Fuel Filler Door Inoperative –
Actuator Binding –
Modification Procedure

MODEL 2005 MY
S-TYPE

VIN N13089-N41136

ILLUSTRATION 1

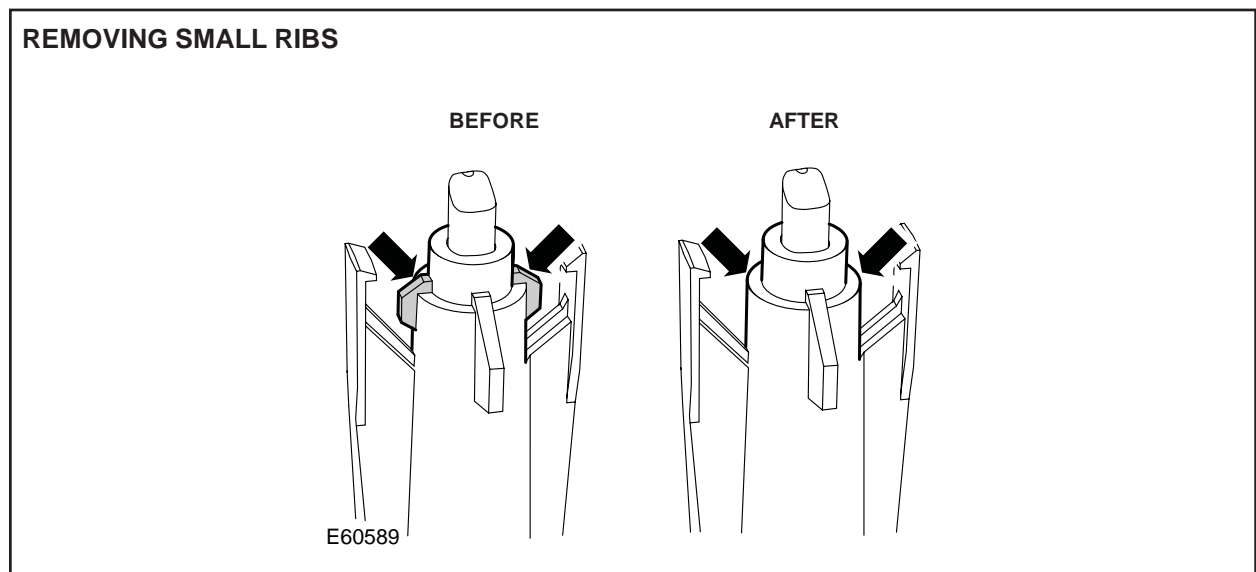
1. Using a suitable craft knife, remove the two small ribs from the fuel filler door actuator (Illustration 1).

ILLUSTRATION 2

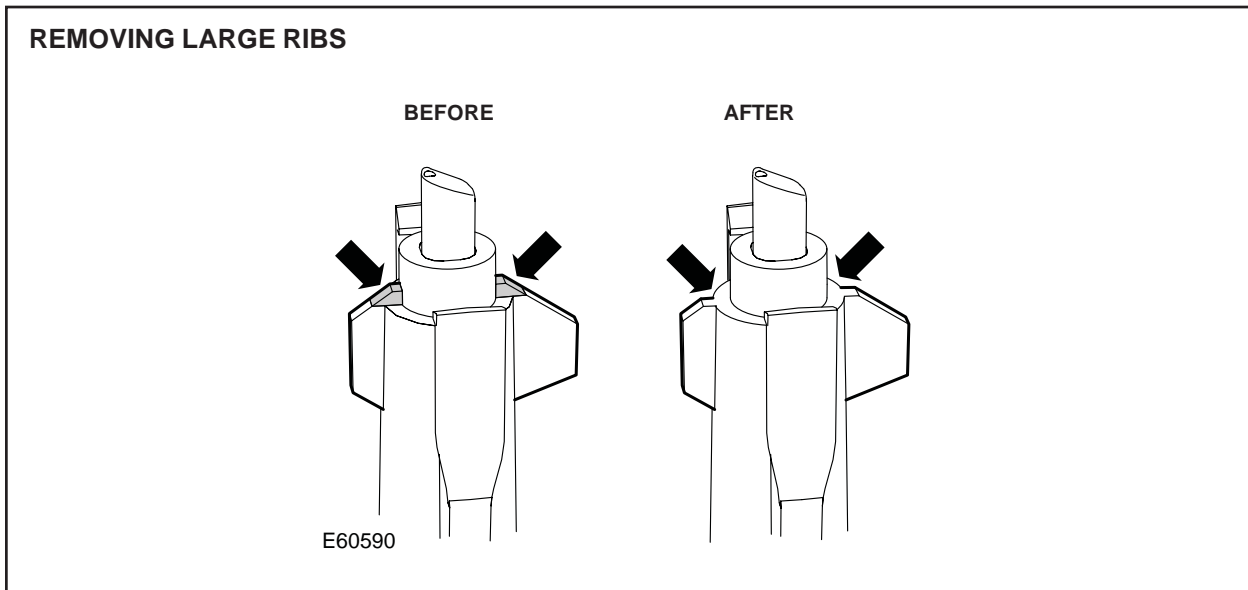
- Using a suitable craft knife, trim the highlighted sections from the two large ribs on the fuel filler door actuator (Illustration 2).
